Subject: **Palo Verde Nuclear Generating Station Units 1, 2, and 3  
Docket Nos. STN 50-528, 50-529, and 50-530  
Renewed Operating License Nos. NPF-41, NPF-51, NPF-74  
Supplemental License Amendment Request to Revise Technical  
Specifications Regarding Response Time Testing of Pressure  
Transmitters and Request for Additional Information Response**

Supplemental LAR and Response to RAIs Regarding Response Time Testing of Pressure Transmitters

**Updated Description and Assessment of Proposed License  
Amendment**

**Figure 2-2. Functional Diagram of 3051N Electrical Components**

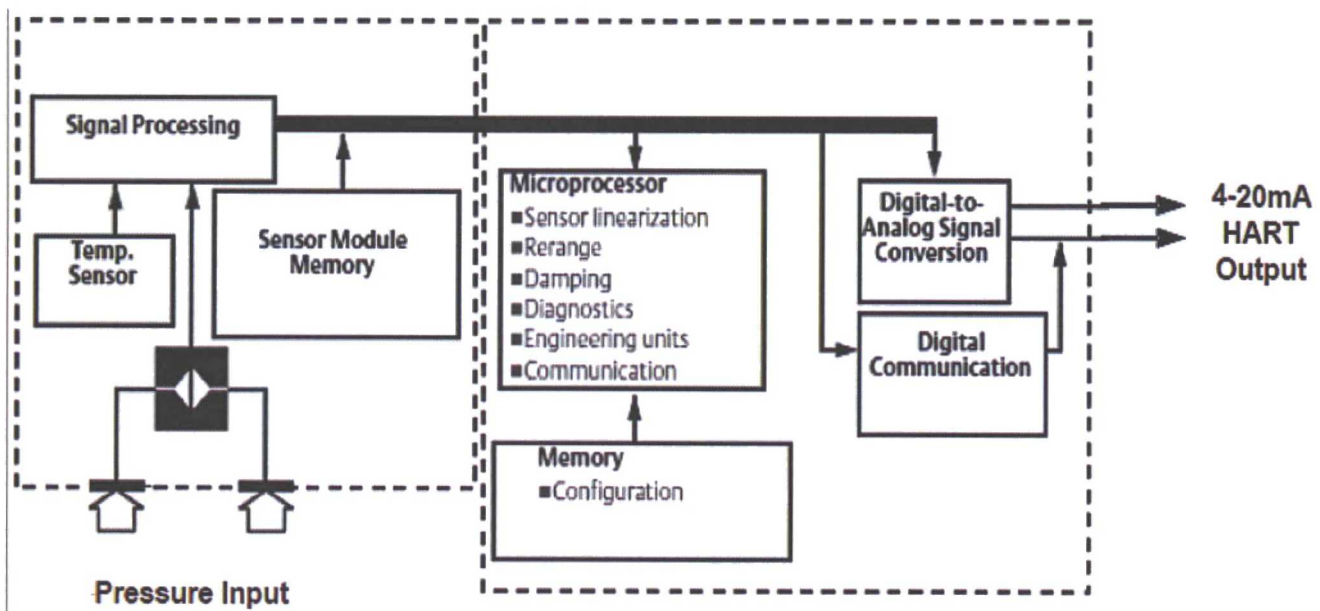
Section 2.1.2 of the evaluation states, in part, that the 3051N series has self-diagnostics but does not provide any further detail on what those self-diagnostics are. Section 2.2.2 states, in part, that a self-diagnostic routine monitors the processing function of the 3051N

series. The failure modes and effects analysis also states that microprocessor failures would be detected by self-diagnostics. In concluding the study, the licensee states, in part, that failure modes that would impact sensor response times will be detected through alternate methods. It appears that self-diagnostic features have a critical role in the detection of potential new failures for the 3051 series transmitters, which is credited as supporting the overall technical justification for elimination of response time testing. Please describe the specific set of self-diagnostic features of the 3051 series of transmitters (and 3051N model) that can detect or protect against failures of transmitters and affect response time.

Section 2.2.2 of the evaluation, states, in part, that "non-specific failures" in the processor hardware or software routines that delay the processing function could theoretically increase time without an apparent gross failure of the device. This would appear to mean that non-self announcing failures could impact response time by causing delays in the processing function of the electronics module. It is not clear whether the licensee is referring to issues such as errors in code or component failure within the electronics module. Please describe the non-specific failures that could affect response time.

The 3051 series transmitters and specifically the 3051N, which is a quality dedicated 3051C (commercial) transmitter, perform continuous self-diagnostics. The self-diagnostics provide detection and annunciation of faulted conditions. Annunciation is provided through the ability to drive the transmitter to a saturated high or low signal based on errors that can affect transmitter operation. This is referred to as the alarm mode. Errors within the electronics module that could affect response time are expected to result in gross output changes that would be detected by the self-diagnostics and made apparent with the associated alarm mode driving the signal high or low.

The diagnostics categorize errors into two sub-groups. The first set is error messages that contain conditions that will affect transmitter operation. These errors will result in the transmitter output being driven high or low based on the transmitter's selected configuration. The second set of messages is warnings that reflect operational conditions, but do not necessarily affect transmitter operation. The reportable diagnostic messages provide insight into the checks performed by the self-diagnostics, which include memory verification routines and electronics board monitoring. The following diagnostic messages are provided in the 3051N reference manual 00809-0100-4808, Rev CA, June 2008.

From the diagnostic messages provided in the 3051N user manual, it can be seen that the self-diagnostics monitor parameters such as output signal, electronics board, memory, and transmitter configuration. The diagnostics provide detection and annunciation of these faulted conditions which could affect transmitter operation.
